PORO POINT MANAGEMENT CORPORATION

PUBLIC BIDDING OF THE CONTRACT FOR THE 1) SUPPLY, DELIVERY, INSTALLATION, TESTING AND COMMISSIONING OF TWO (2) UNITS BRAND NEW CONSTANT CURRENT REGULATOR (CCR) AND 2) REHABILITATION, REPAIR AND REPLACEMENT OF DEFECTIVE PARTS, TESTING AND COMMISSIONING OF MAIN CONTROL DESK

SUPPLEMENTAL/BID BULLETIN NO. 1

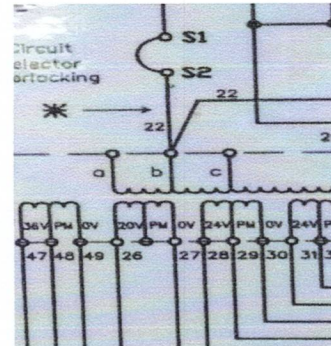
| Questions | Answer of the Bids and Awards Committee |
|--|--|
| Per your specification on the Maximum Output Voltage of CCR you required 758V with control voltage of 20vdc - 60 vdc, is | Your proposed 757 V with control voltage of 24 vdc to 60 vdc is within the range of voltages, but the existing schematic diagram of the CCR has a 20Vdc |

757V with control voltage of 24 vdc to 60 vdc acceptable since it is within the range and the existing Remote Control is 48 vdc only.

output. Please see the schematic diagram below for your reference or you may check or verify at site during the site inspection if your proposed unit is compatible to the whole system.

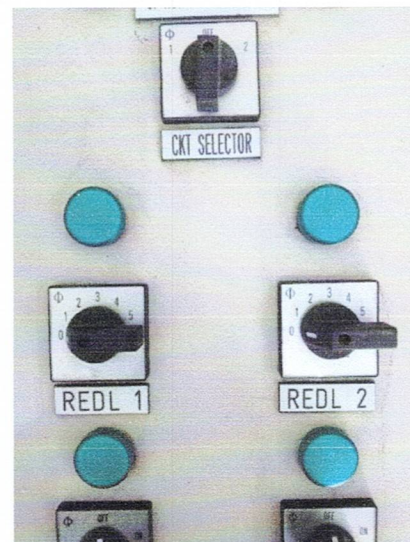
Per your specification you required 5 steps brightness control, can we offer up 7 steps Brightness control (can be set to Step 1 to 5 Brightness Control at the Remote control).

The existing design of the MCD selector switches only have five (5) steps control. The Supplier may offer more superior specifications at no additional cost to PPMC. Please see below the picture of the existing selector switches for your reference or you may check or verify at site during the site inspection if your proposed unit is compatible to the whole system.

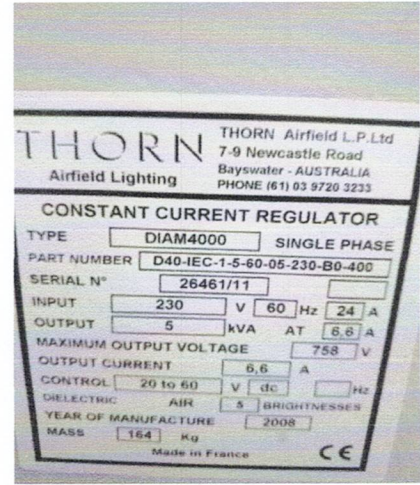
With regards to input of CCR, per your specs for 5kVA is 24 A, Each manufacturer has its own standard, can we offer 5 KVa CCR up to 26A input current.

The Supplier may offer more superior specifications at no additional cost to PPMC, but the maximum output voltage must be 758V and the constant current output is 6.6A. Please see below the picture of the existing CCR specifications for your reference or you may check or verify at site during the site inspection if your proposed unit is compatible to the whole system.
